1199 Panigale Safety Upgrades
Models: MY 2012 and MY 2013 Panigale (All Versions)
Recall Bulletin RCL-12-006

Date: Tuesday, August 7th, 2012
To: Dealer Principal, Service Manager, North American Dealer Network
From: Austin Gray, Technical Director; Jonathan LaForte, Technical Manager

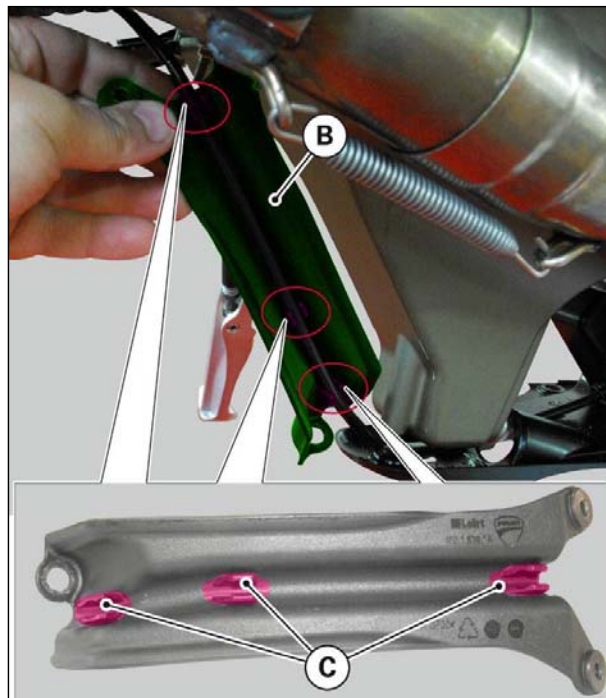
- 8) Release the exhaust butterfly valve cable from the clips of the **exhaust butterfly valve Bowden cable support (A)** and remove the latter.

- 9) Install the new **exhaust butterfly valve Bowden cable support (B)** part no. 46015393A and engage the cable inside the **three clips (C)**.

- 10) Fit the new exhaust butterfly valve Bowden cable support (B) part no.46015393A and tighten the **bottom screw (7)** to **$5\text{ Nm} \pm 10\%$** after applying **LOCTITE 222** , then tighten the **two top nuts (8)** to **$6\text{ Nm} \pm 10\%$** .

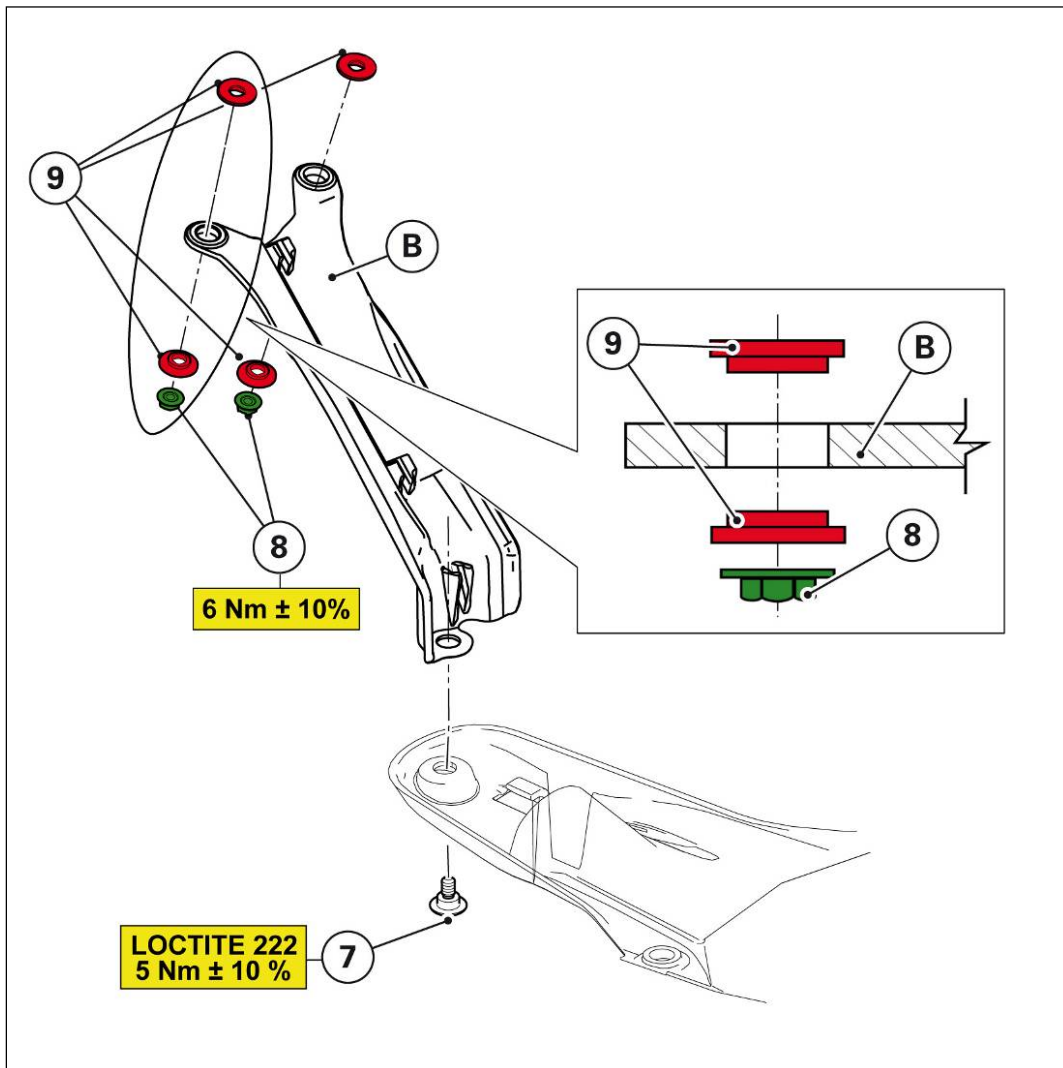
Fit the four **spacers (9)** correctly, as shown below.

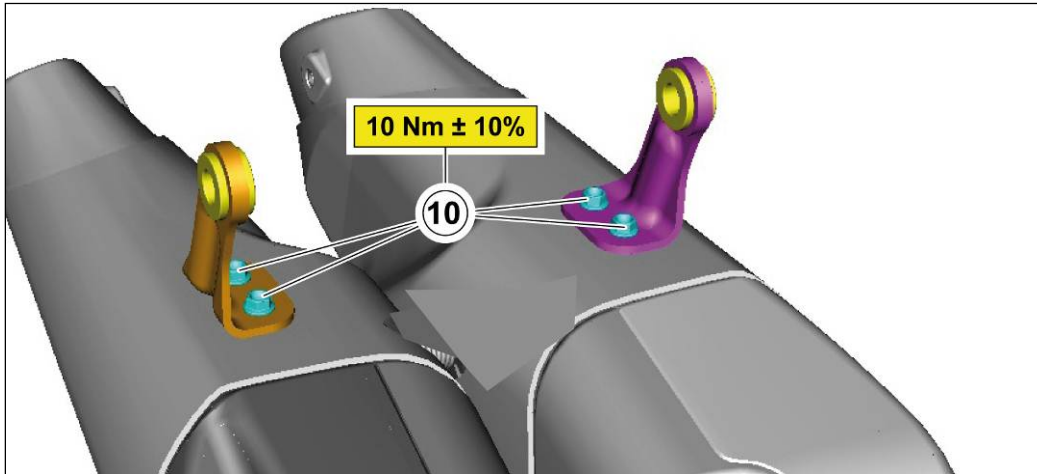
- 11) Before refitting the silencer assembly tighten all silencer central bracket retaining screws (operation already described under Tips&Tricks no. 54).

Tighten screws (10) to **10 Nm ± 10%**.

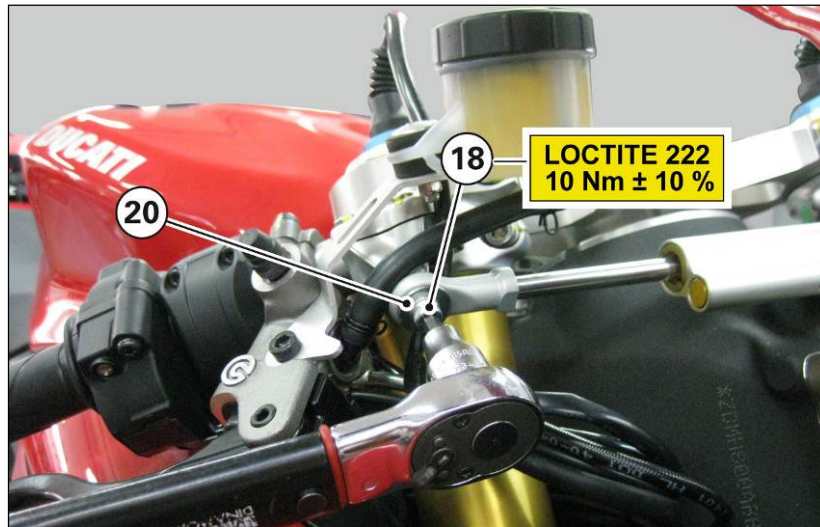
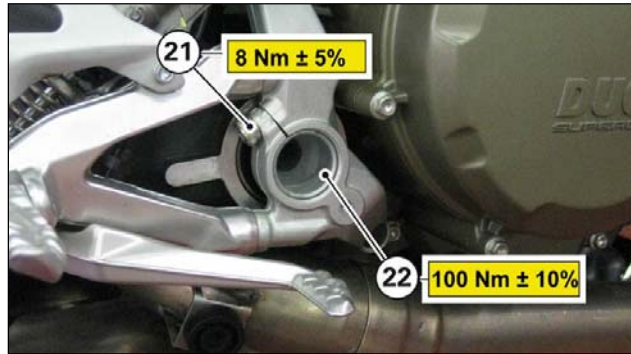
- 3) Remove the **screw (18)** retaining the **steering damper (19)** to the right-hand handlebar, remove any trace of threadlocker and thoroughly degrease the surface.
- 4) Start the **screw (18)** with **washer (20)** in-between.

- 5) Tighten the **screw (18)** with **LOCTITE 222** to **10 Nm $\pm$ 10%**.

Washer (20) must be installed only on S versions, i.e., where an Ohlins steering damper is fitted. The washer must NOT be installed on BASE versions equipped with SACHS steering damper.

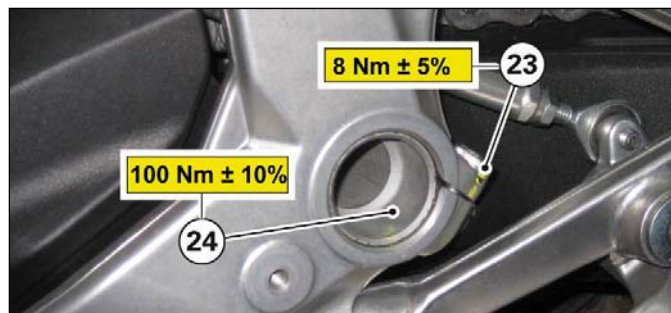
- 1) Loosen the **screw (21)** from clamp on RIGHT-hand swinging arm shaft.
- 2) Loosen the **RIGHT-hand swinging arm shaft (22)** by 180° without removing it.
- 3) Tighten **RIGHT-hand swinging arm shaft (22)** to **100 Nm ± 10%**.
- 4) Tighten clamp **screw (21)** to **8 Nm ± 5%**.

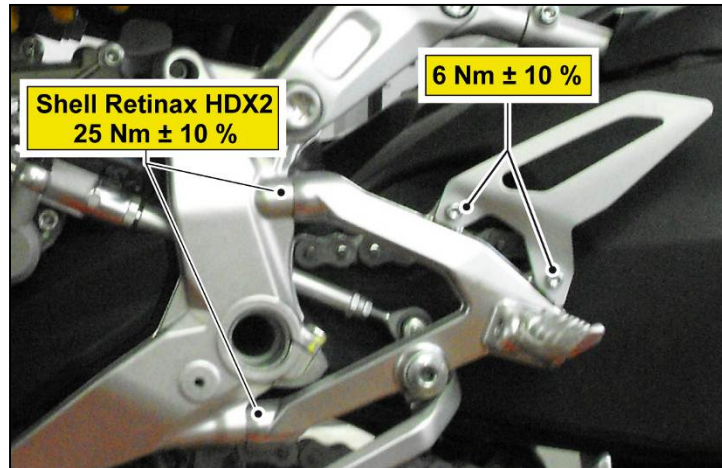
- 5) Slacken the **screw (23)** from clamp on LEFT-hand swinging arm shaft.
- 6) Loosen the **LEFT-hand swinging arm shaft (24)** by 180° without removing it.
- 7) Tighten **LEFT-hand swinging arm shaft (24)** to **100 Nm ± 10%**.
- 8) Tighten clamp **screw (23)** to **8 Nm ± 5%**.

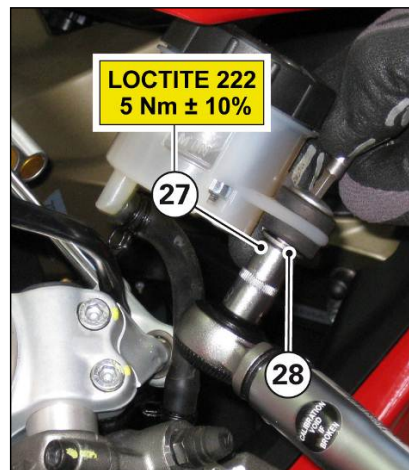
- 1) Remove **nut (25)** retaining the front brake fluid **reservoir (26)**.

- 2) Start the new **cap nut (27)** and add the **washer (28)**. Tighten the **cap nut (27)** with LOCTITE 222 to 5 Nm $\pm$ 10%.

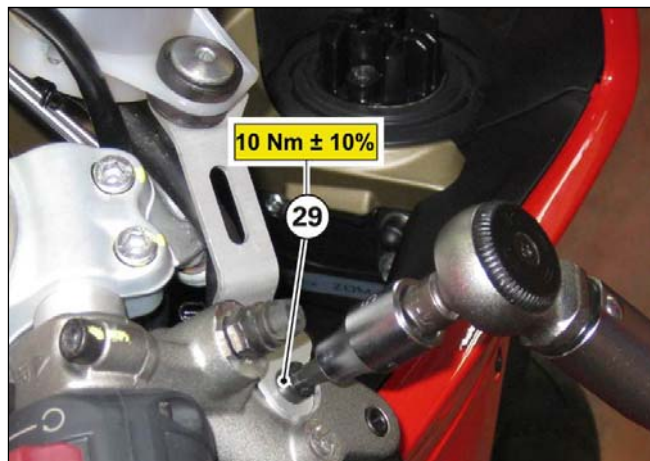
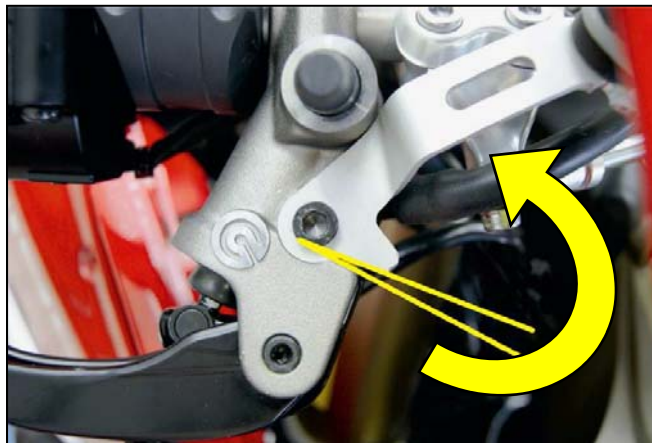
- 3) Tighten the **screw (29)** retaining the reservoir mounting bracket to the right-hand handlebar to **10 Nm** **±10%**.

When tightening the screw, turn the reservoir mounting bracket as shown.
